HPR Gas Console Firmware Upgrade

Field Service Bulletin

805040 – Revision 0 – September, 2005

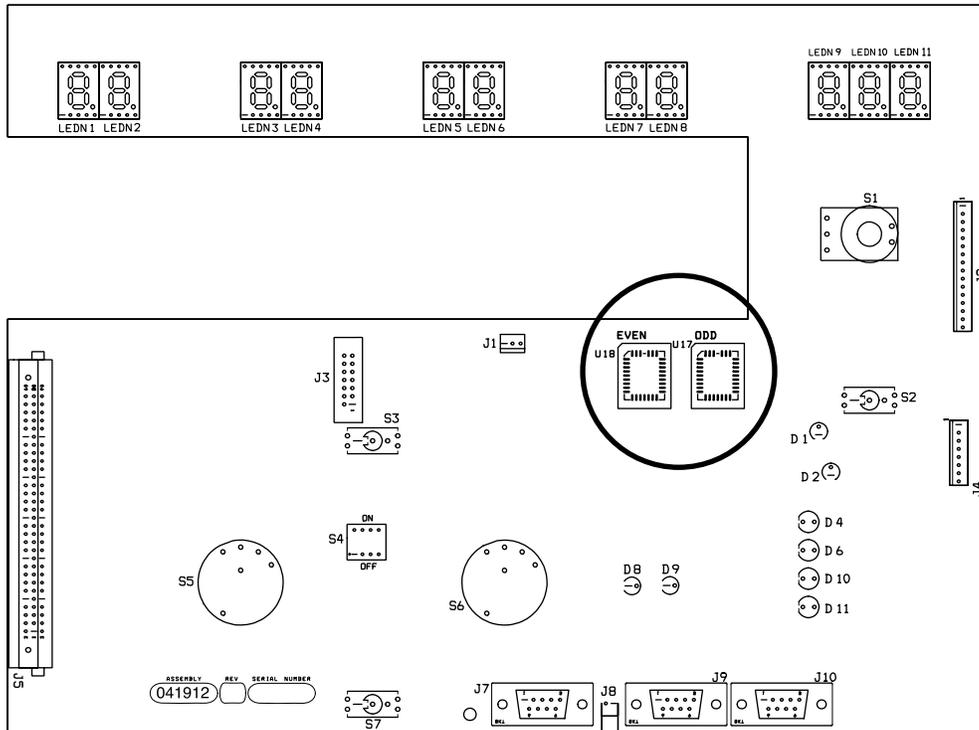
4. Remove the even (U18) and odd (U17) chips from the board using the extraction tool (027338) provided in this kit. See figure above
5. Install new chips (081093) onto the control board.

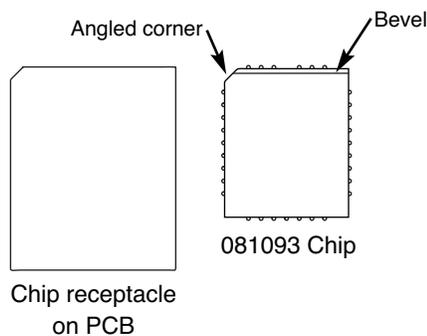
NOTE: Make sure the chips are oriented correctly before installation. There is a bevel on the top edge of each chip and the upper left corner is angled (see figure below).

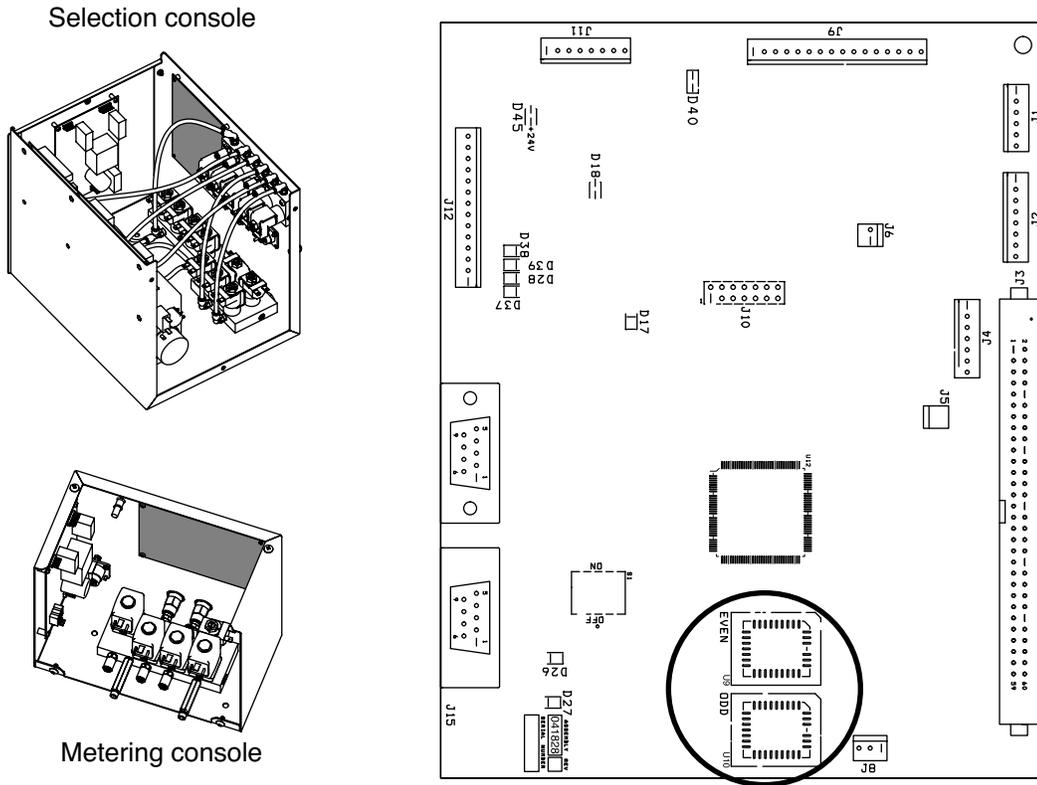
1. Turn OFF all power to the system.
2. Remove the covers from the selection console and the metering console to access the control PCB (see figure above).
3. Remove the even (U9) and odd (U10) chips from the board using the extraction tool (027338) provided in this kit.
4. Install new chips (081096) onto the control board.

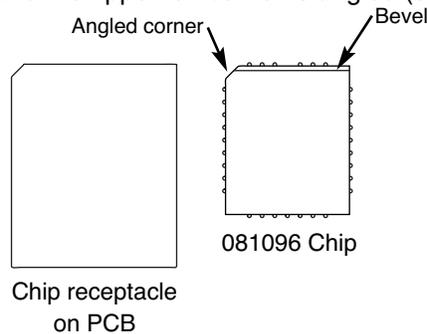
NOTE: Make sure the chips are oriented correctly before installation. There is a bevel on the top edge of each chip and the upper left corner is angled (see figure below).
